SHEARON HARRIS NUCLEAR POWER PLANT, UNIT 1
DOCKET NO. 50-400 / RENEWED LICENSE NO. NPF-63

**SUBJECT: RESPONSE TO REQUEST FOR ADDITIONAL INFORMATION (RAI)
REGARDING APPLICATION FOR EMERGENCY OPERATIONS FACILITY
(EOF) CONSOLIDATION**

Response to NRC Request for Additional Information

FIGURE B-11
OCONEE NUCLEAR STATION
Common EOF - Multi-Site Event Staffing

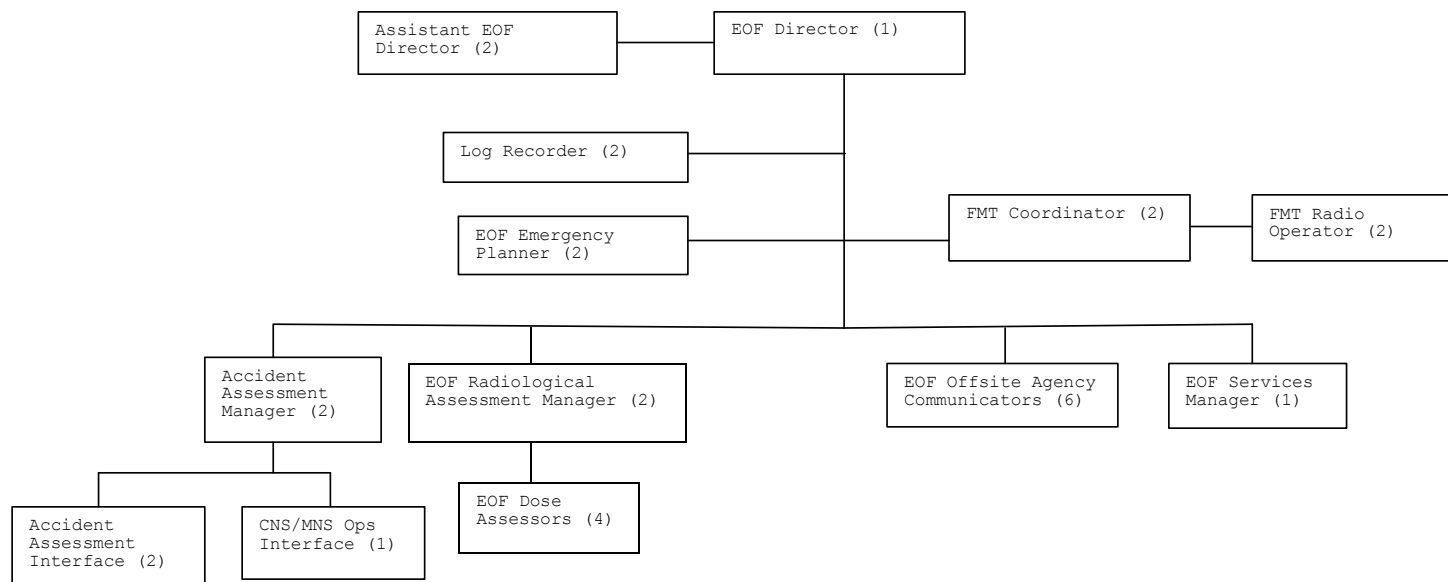
On August 2-3, 2016, the NRC staff performed a walk down of the Duke Charlotte EOF. During the NRC staff's walk down, it was verbally indicated to the staff that the facility could support a simultaneous response for events at more than two sites. As identified above, Duke Energy describes processes and protocols for accommodating simultaneous responses at up to two sites. Please describe facility capabilities and what process and protocols have been established to support accommodating simultaneous responses at more than two sites. Include how Duke would further staff the facility, establish command and control, and effectively coordinate event response during multi-site simultaneous events.

The Charlotte EOF was designed with the physical capabilities (e.g. space, equipment, etc) to support simultaneous responses for up to three sites. As Duke Energy has not committed to (and is not committing to in this response) supporting events at more than two sites simultaneously, a formal process for this scenario has not been established. However, with regard to staffing, command and control, and coordination, the Charlotte EOF would expand from two to three sites in a corresponding manner as the existing process for expanding from one to two sites (see Figure B-11 below from the ONS Emergency Plan, which shows the EOF organization for a two site event). The normal EOF staff complement would be augmented with

additional personnel as needed, particularly for those positions which could not reasonably perform their responsibilities for multiple sites. The EOF Director would assume overall responsibility, whereas there would be an Assistant EOF Director for each affected site. The main EOF area contains three segregated areas each with its own equipment (e.g. computers, phones, wall displays) to support the EOF functions for each affected site. The rooms surrounding the main EOF area with major support functions (e.g. offsite communications, radiation assessment, accident assessment, offsite monitoring) also include separate space and equipment for up to three sites. Since sufficient space and equipment is available for the key positions to support three simultaneous events, each position would be able to follow their normal process for completing their responsibilities. Furthermore, visual aids such as color coding would be used to differentiate staff for the different sites. Finally, as stated in Section 3.1.1 of the subject license amendment, the Technical Support Center (TSC) will serve as a backup to the EOF. This would allow the flexibility of the TSC for any of the sites to perform the EOF functions. This could be for the duration of the event or the responsibilities could be transferred between facilities as needed, likely depending on event severity.
